SERVICE INSTRUCTIONS

No. 0627-159
ATA Code 76-10

SUBJECT: ENGINE CONTROLS - POWER CONTROL - MODIFICATION OF ENGINE QUADRANT CONTROLS FRICTION MECHANISM.

Figure 1.

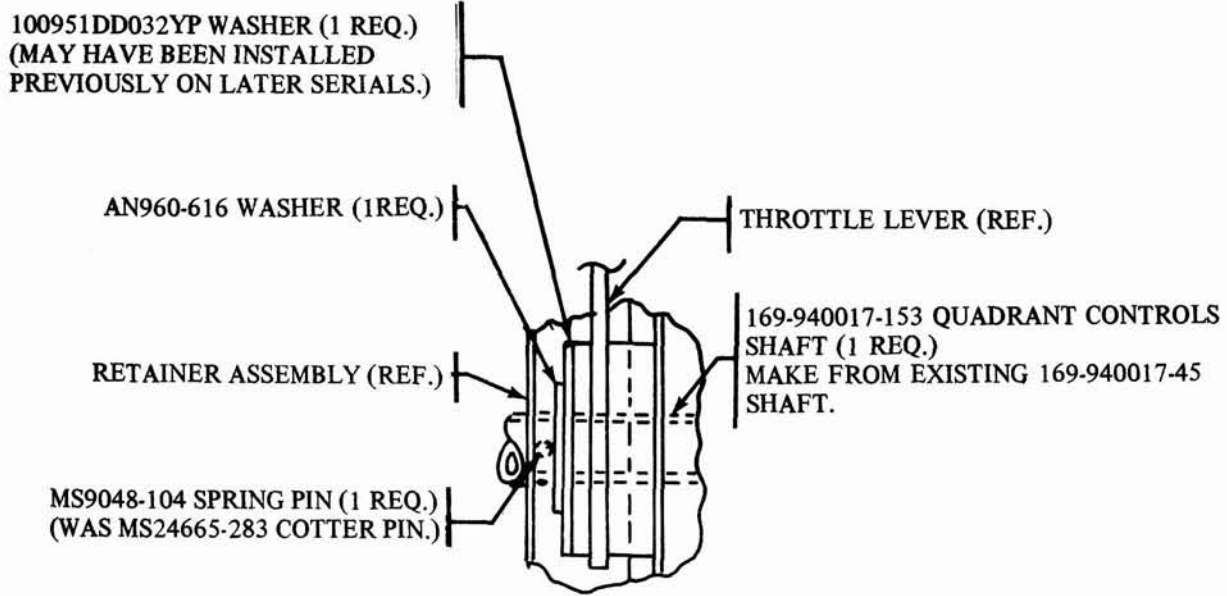
friction lock mechanism, remove the 169-940017-43 nut from the right hand end of the 169-940017-45 quadrant controls shaft (Figure 1).

4. Remove the MS24665-283 cotter pin (Figure 1) located approximately 3/8 inch from the left hand end of the 169-940017-45 shaft. Remove the shaft from the friction lock mechanism by pulling out the shaft from the right hand side. Discard the MS24665-283 cotter pin.

5. Rework the 169-940017-45 shaft into a 169-940017-153 shaft by drilling out the existing cotter pin hole to .125 to .129 inch diameter.

a. If a 100951DD032YP washer is not now installed at the location shown in Figure 1, remove the existing washer at that location and replace it with a 100951DD032YP washer.

b. Install an AN960-616 washer at the location shown in Figure 1. Remove the existing washer at that location (if installed) and discard.

Figure 2.

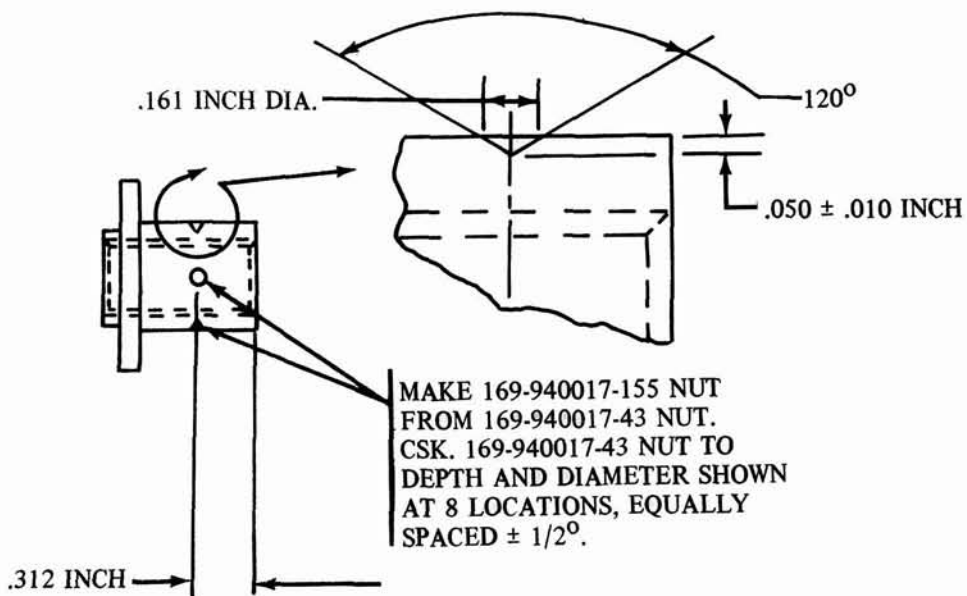
8. Rework the 169-940017-43 nut into a 169-940017-155 nut by drilling eight countersunk holes in the nut as shown in Figure 2.
